CITY OF CONWAY, ARKANSAS HISTORIC DISTRICT COMMISSION

HISTORIC DISTRICT COMMISSION

November 27, 2023

824 Davis Street - New Single-Family Residence

PLAN INFORMATION:

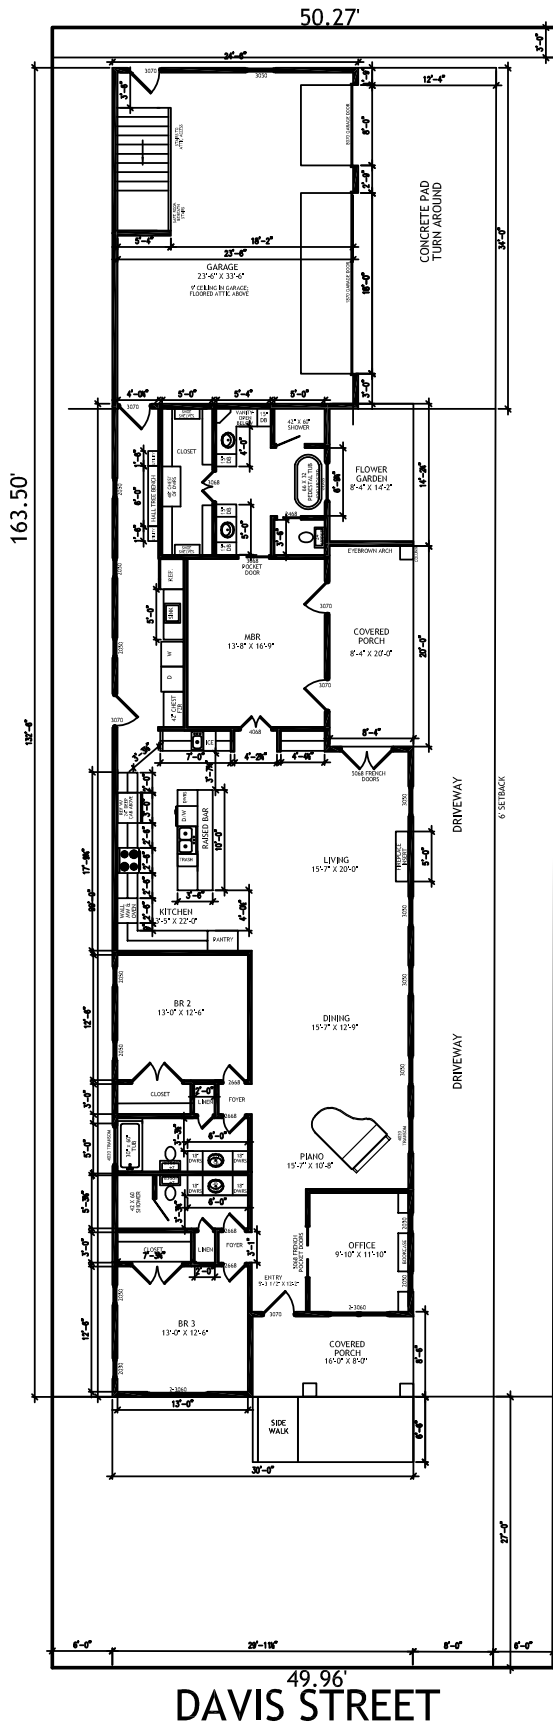
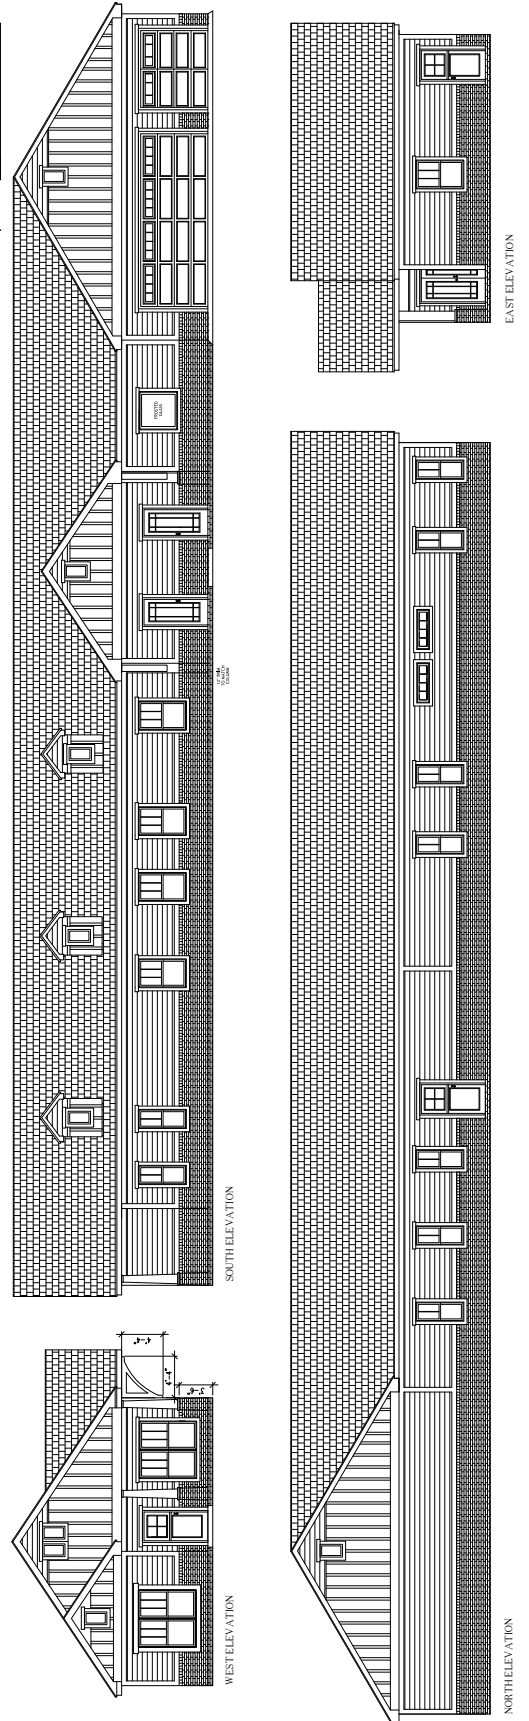
This is a gable roof type with what appears to be shingles. It mimics the single-family residence it replaces from the front façade with one variation being a side porch gable located near the center of the residence.

Proposal includes brick, 6" shiplap siding, and board & batten accents. In addition to the brick, the material types will need to be wood or fiber cement. Synthetic siding such as vinyl, aluminum, and synthetic stucco (EIFS products) are prohibited. The proposed material pattern complements that in the neighborhood in terms of variation between different sections of the façades.

The door and window material types are not indicated on the submitted plans. They will need to be true divided light as fake muntin bars are prohibited. There appear to be fixed windows in the attic, some of which are styled as dormers. These fixed windows are supportable. There also appear to be rectangular, horizontal fixed windows in one bathroom and another square, frosted glass fixed window in the master bathroom. These are on the side elevations and are subordinate to the other detailing on the house. As a result, staff can support their use. The spacing of windows and doors is appropriate. No shutters are proposed.

The proposed residence has a 27' front setback, 3' rear setback, a 6' side yard setback, and a 14' side yard setback. The average front yard setback among 7 residences on the same block is 25'. To comply, the proposal needs to have a front yard setback between 21' and 28'. The proposal conforms to front yard setbacks. The proposal conforms to side yard setbacks. The proposal conforms to rear yard setbacks according to the Robinson Historic Guidelines, however, it does not meet fire code. The house will need to be shifted 2 feet west or 2 feet of the residence will need to be removed.

The single-family residence with attached garage results in a lot coverage of 44%. Including the driveway with a concrete turnaround, the lot coverage is approximately 62%. The driveway needs to be concrete, concrete ribbons, or permeable pavers. The applicant should be able to reduce the lot coverage by constructing concrete ribbons or permeable pavers. Alternatively, the HDC may grant an exception and permit the project with a lot coverage of 62% given the following:

The front façade matches the scale of homes in the neighborhood. The length of the residence exceeds the established pattern of the neighborhood as it is 133' long. The height of the structure is compatible with the neighborhood.

The garage is located at the rear of the primary structure and is accessed via a long driveway which runs along the side of the residence. Although larger than historical garages, it is not visible from the street and the detailing echoes that of the residence.

2. HVAC equipment shall be screened from the public right-of-way through its positioning in relation to other structures or through vegetative cover.
3. Prior to issuance of a Certificate of Appropriateness, applicant shall provide Planning Staff with a site plan indicating the residence adhering to 5' rear yard setback.

4. Roofing shall be asphalt or composition type shingles. Metal roofing is not allowed.
5. Siding shall be composed of brick and wood or a wood-like material such as Hardie® siding/LP® SmartSide®.

6. Driveway shall be 8'-10' in width and be composed of concrete, concrete ribbon, or permeable pavers. If HDC will not permit an exception to the lot coverage maximum, the driveway must be composed of a concrete ribbon or permeable pavers.

7. Windows must be true divided light, fake muntin bars are prohibited. Fixed windows are allowed in the bathroom areas and in the attic dormers. All other windows must be at least one-over-one.

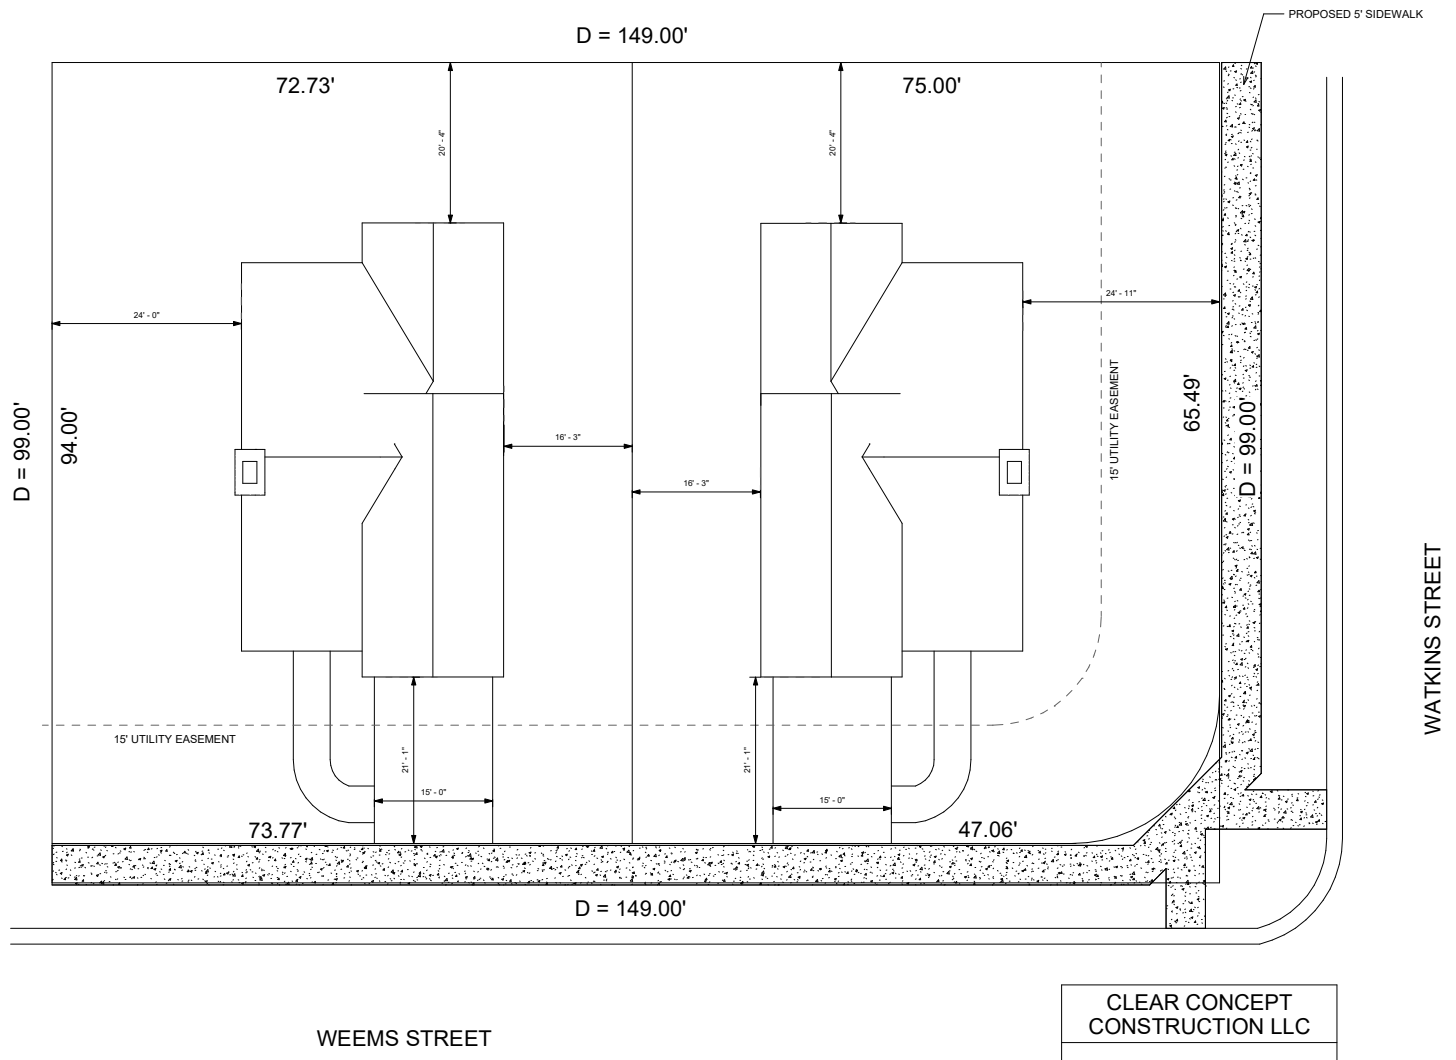
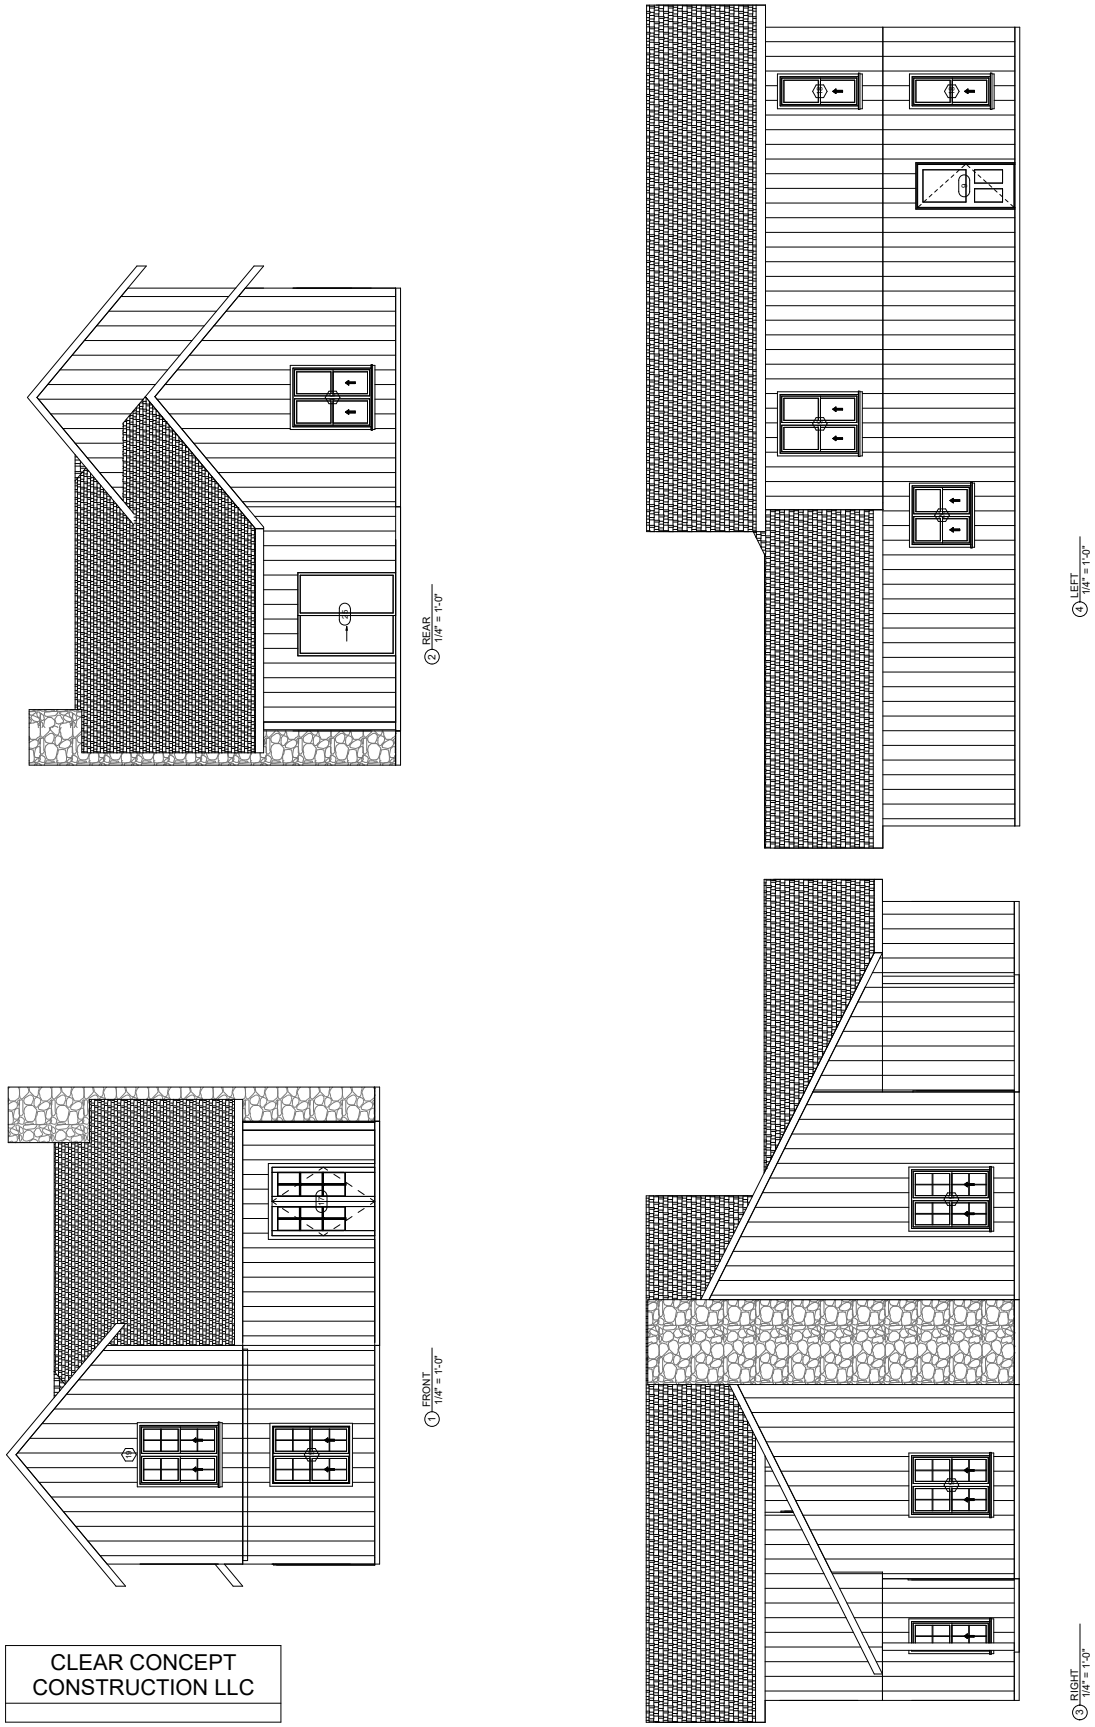
Additional windows are recommended to meet the 25%-40% of the front façade and to enhance the overall rhythm.

An open front porch with an 5' depth is proposed. The porch needs to be 6' deep. The proposed windows should feature wide trim and at least one-over-one design. The elevations indicate wide trim with four-over-four panes. If muntin bars are proposed, they must be true divided lights. Fake muntin bars are prohibited.

No shutters are being proposed which is desirable. The applicant is proposing a gable roof. This is compatible with surrounding homes. HVAC equipment will need to be screened from view.

4. 25-40% of front elevation must contain windows. Prior to issuance of a COA revised elevations showing additional windows shall be approved by Planning Staff.

5. The porch must be at least 6' deep. Prior to issuance of a COA, revised plans showing a 6' deep porch must be approved by Planning Staff.
6. Driveway shall be concrete, pavers, or permeable paving and between 10' and 12' wide.

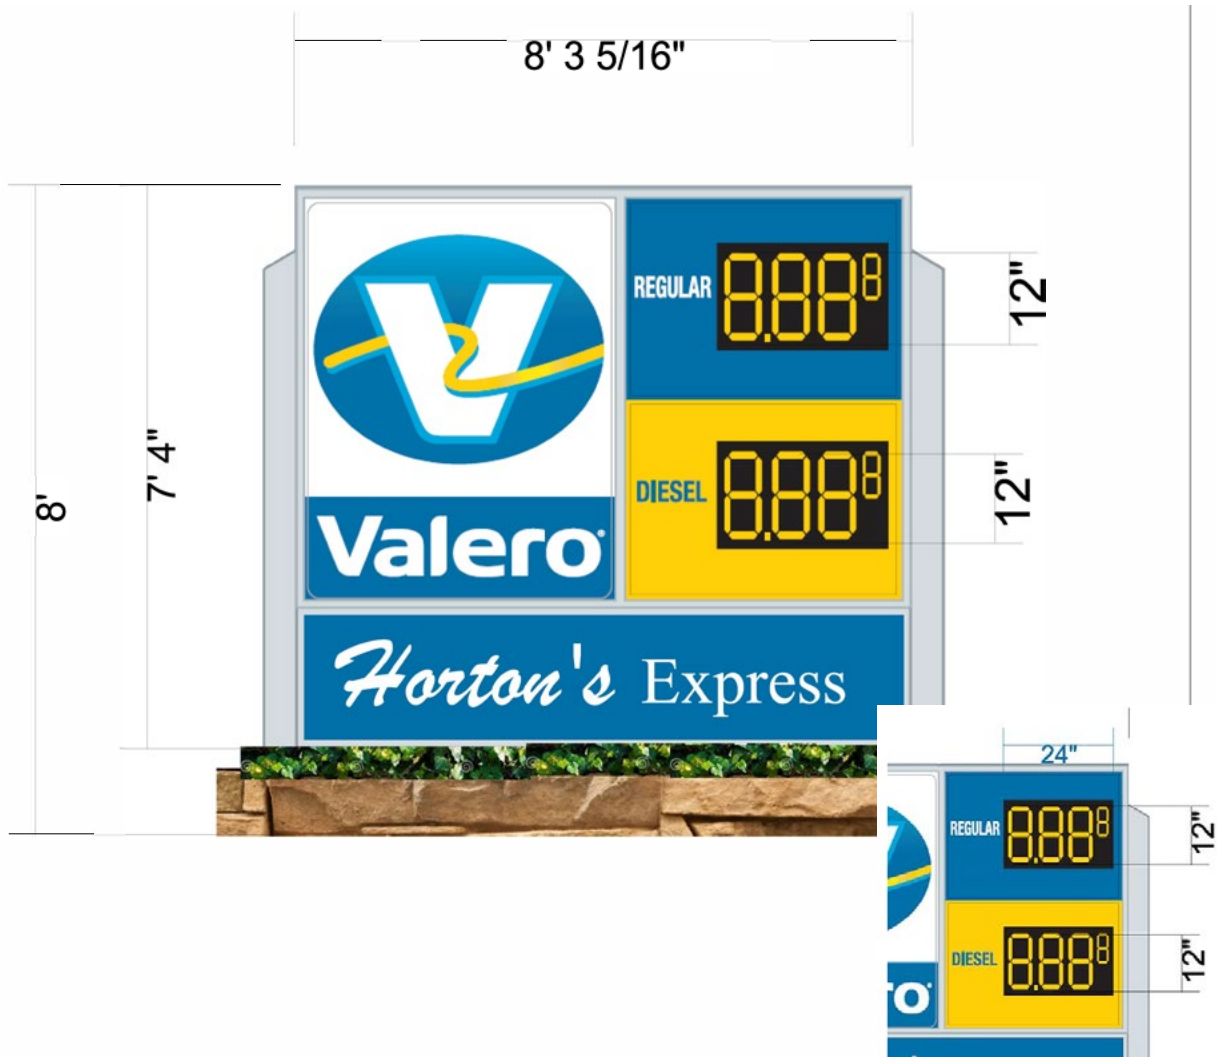
The proposed sign is 8' tall and approximately 60 sf in area, necessitating an exception by the HDC.

This sign is typical for fuel stations and is located on a major thoroughfare at the corner of the historic overlay and other commercial businesses on Harkrider St.

1. Applicant shall adhere to regulations outlined in Article 12 (Sign Code) of the Conway Zoning Code.
2. Landscaping is required around the base of the sign.
3. Sign shall be located out of the right-of-way and at least 5' from the property line.

Changes proposed to approved design

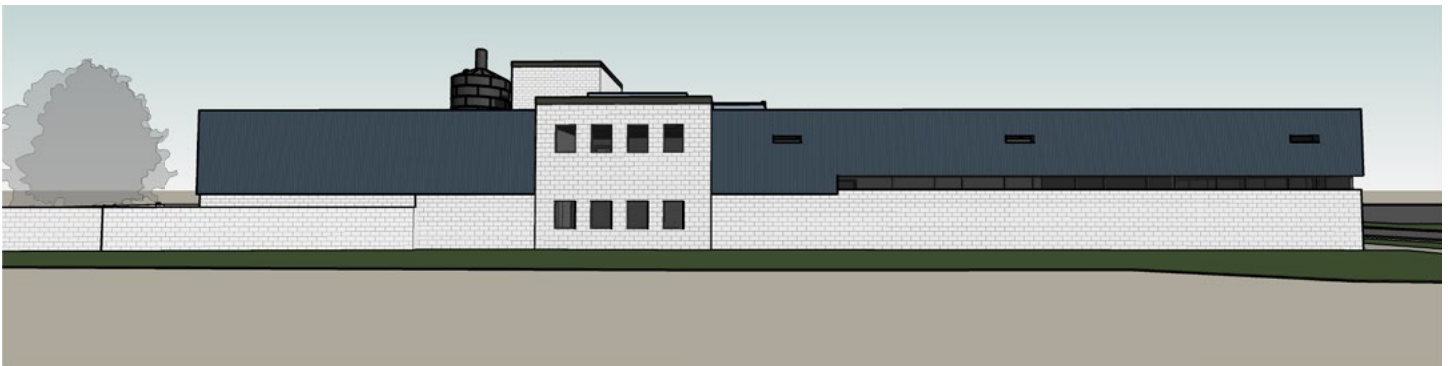
All 4 façades incorporate an appropriate amount of articulation. While the western and southern elevations do not incorporate the appropriate number of windows, staff understands that this is due to the adaptive reuse of existing building materials, interior design needs, as well as desired ambiance (i.e. not wanting headlights to encroach into dining and recreational areas). The differing types of building materials and visuals throughout all 4 façades provide an appropriate rhythm.

Applicant shall confirm that proposed glazing meets transparency requirements. In addition to glass, the applicant is proposing to apply stucco over the existing CMU. Material must be true a stucco material, not EIFS. The following is a list of proposed materials:

5. Fencing proposed around outdoor pickleball court shall be 70% open and shall be constructed of metal. Plastic, chain link, and wood are prohibited.
6. Any material treatment applied to existing CMU be true stucco; EIFS is not permitted on any first-floor areas.

7. 85% of all first story glazing shall be transparent.
8. All signage shall comply with Old Conway Overlay District guidelines and regulations detailed in Article 12 of the Conway Zoning Code. All signage is permitted separately from all review and building permit processes.
